MPC 5000 Upgrade Manual

Katadyn Desalination, LLC
Spectra Watermakers
PH 415.526.2780 FX 415.526.2787
www.spectrawatermakers.com
Revised 03.06.2006

MPC-5000 PCB Upgrade Instructions

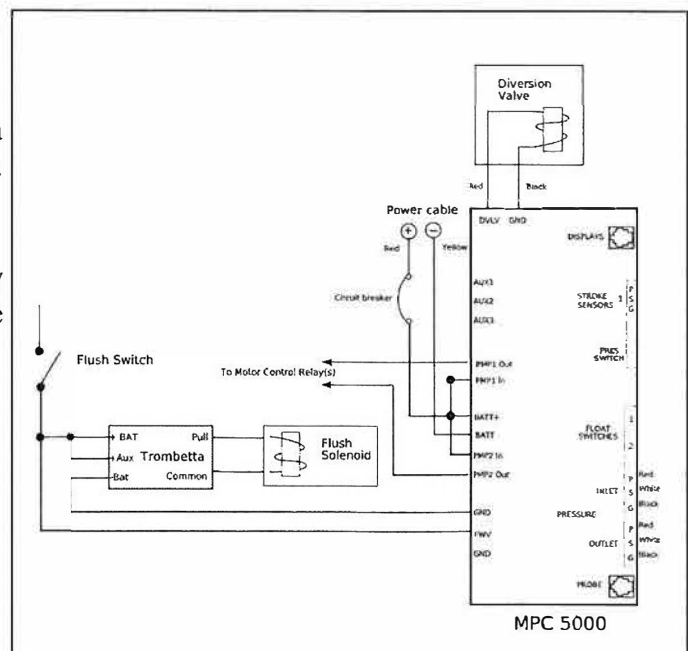
The new boards allow the operator to program the system from the display panel and over-ride the safety shutdowns as described in the MPC-5000 Owner's Manual. The primary differences between the two models are in the Feed Pump Outputs (PMP1 & PMP2), the Diversion Valve Output (DVLV), the Fresh Water Flush Output (FWV), And the AUX2 & AUX3 outputs.

When changing from MPC-3000 to MPC-5000 the following changes must be made.

PUMP OUTPUTS: The PMP1 and PMP2 terminals have been renamed PMP1 IN and PMP2 IN. The adjacent GND terminals are renamed PMP1 OUT and PMP2 OUT. Originally, system voltage was applied to the PMP terminals when the relays pulled in. Now there are Normally Open relay contacts between PMP IN and PMP OUT. When replacing the MPC-3000 board with an MPC-5000 board system voltage must be provided to the relay contacts by installing a jumper between BATT+, PMP2 In, and PMP1 In. The wires that originally went to PMP1 and PMP2 must be moved to PMP1 OUT and PMP2 OUT. The ground wire that originally was on the GND terminal may be connected to any other GND terminal on the board.

The Aux 2 terminal was used for operating a feed water boost pump on the MPC-3000. The MPC-5000 uses Aux 3 for this function.

On Catalina Watermakers the black relay mounted on the BATT- terminal must be relocated or allowed to float.
